Irish Standard
I.S. 327-1:1987

Domestic Installations Using Liquefied Petroleum Gases

AMENDMENT

NO. 2 : 1988

Figure 5. Position of balanced flue terminal.

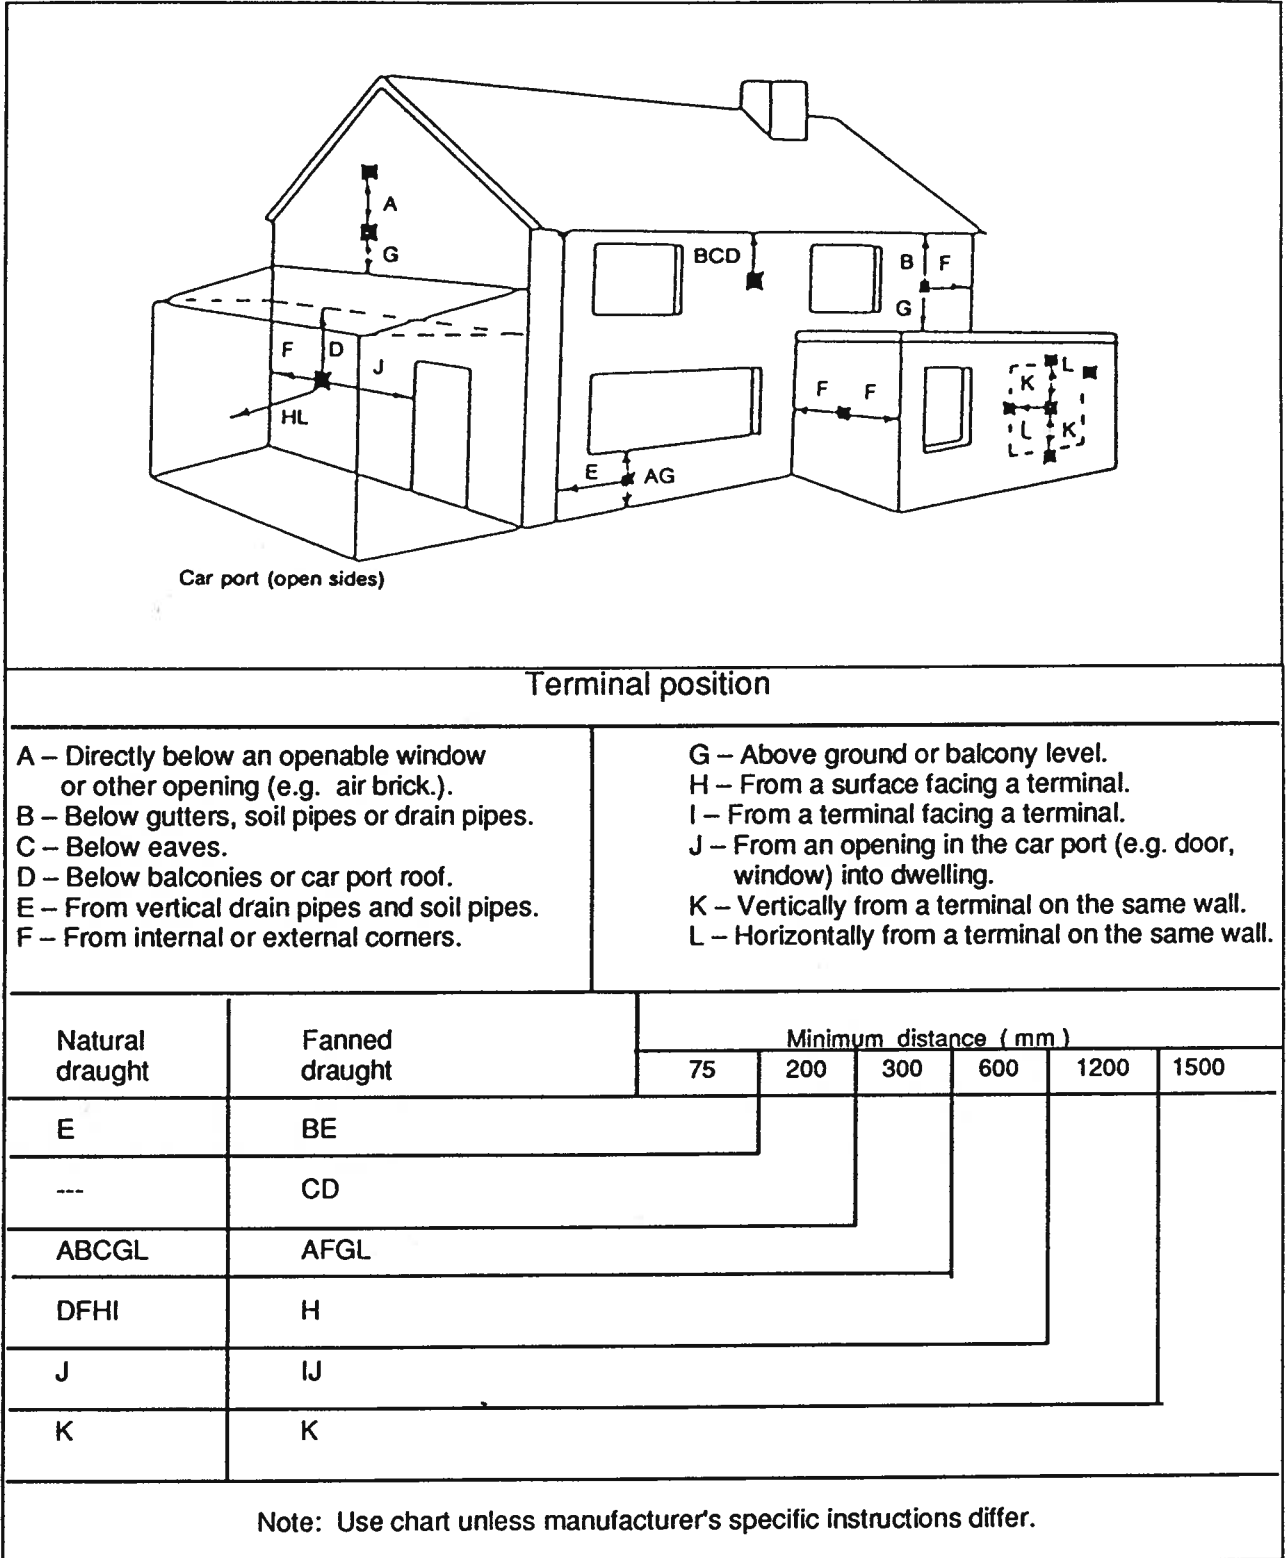
PART 1. Page 27. Delete the existing Figure 11 and substitute Figure 5 as follows:
